SUBJECT: IN THE MATTER OF 238 NUCLEAR ISLAND
GENERAL ELECTRIC STANDARD SAFETY ANALYSIS REPORT
(GESSAR II) DOCKET NO. 50-447

CHAPTER 15 RADIOLOGICAL DOSE CALCULATIONS WITH
POOL SCRUBBING CREDIT

SUBJECT: IN THE MATTER OF 238 NUCLEAR ISLAND
GENERAL ELECTRIC STANDARD SAFETY ANALYSIS REPORT
DOCKET NO. 50-447

REVISION OF CHAPTER 15 RADIOLOGICAL DOSE CALCULATIONS

Figure 15.6-2. Post-LOCA ~~Leakage Pathways~~ Fission Product Retention Systems

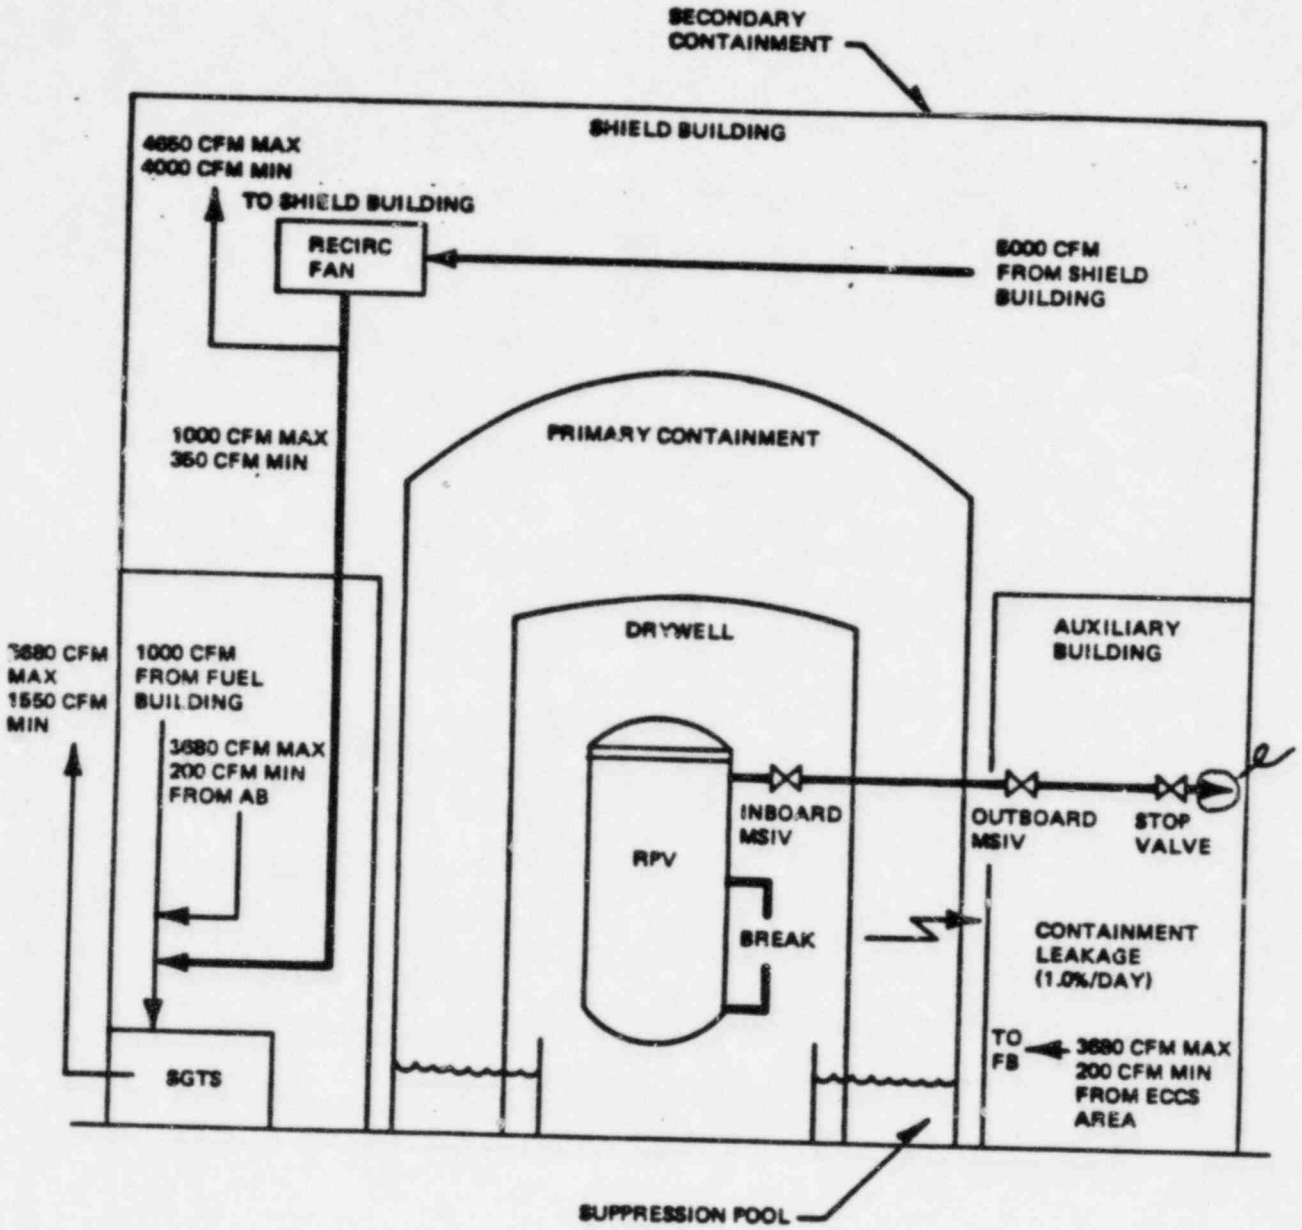
A schematic of the transport pathway is shown in Figure 15.6-2.

The Mark III containment is designed with the drywell and suppression pool totally enclosed within the containment wetwell. In this configuration, any fission products released to the drywell, or discharged through the safety/relief valves, must pass through the suppression pool before they can reach the containment wetwell airspace. Once in the primary containment airspace, the transport pathway consists of limited leakage from the primary containment to the secondary containment by several different mechanisms and discharge to the environment through the Standby Gas Treatment System (SGTS). Consistent with the SGTS design capability and in accordance with R.G. 1.52 and the BWR/6 Standard Technical Specifications, it is assumed that the SGTS has an iodine removal efficiency of 99%.

~~These~~ Transport pathways and ~~any~~ associated retention mechanisms are identified below:

1) Suppression Pool - All fission products discharged from the drywell or safety/relief valves enter the suppression pool 7 to 14 feet under the pool surface. As described in Section 15 D.2, General Electric has performed tests which demonstrate that the suppression pool will act as an extremely effective retention device for particulate fission products discharged into the pool under these conditions. Based upon the testing and modeling documented in Section 15 D.2, a suppression pool scrubbing decontamination factor (DF) equal to 10,000 was applied to reduce the activity of particulate iodine reaching the primary containment airspace. All noble gases and organic forms of iodine were assumed to pass through the pool without retention (i.e., DF = 1). The resulting activity airborne in the containment wetwell airspace due to noble gases and iodine is presented in Table 15.6-8.

2) Primary Containment Leakage - The design basis leak rate of the primary containment and its penetrations is 1.0%/day for the duration of the accident. All of this leakage is to the secondary containment and from there to the environment via the SGTS. Parameters applicable to the primary and secondary containments are given on Tables 15.6-9 and 15.6-10, ~~and the activity airborne in the primary containment is presented in Table 15.6-8~~.

3) Engineered Safety Feature Leakage - Engineered safety feature (ESF) components located outside the primary containment contribute insignificant leakage to the secondary containment.
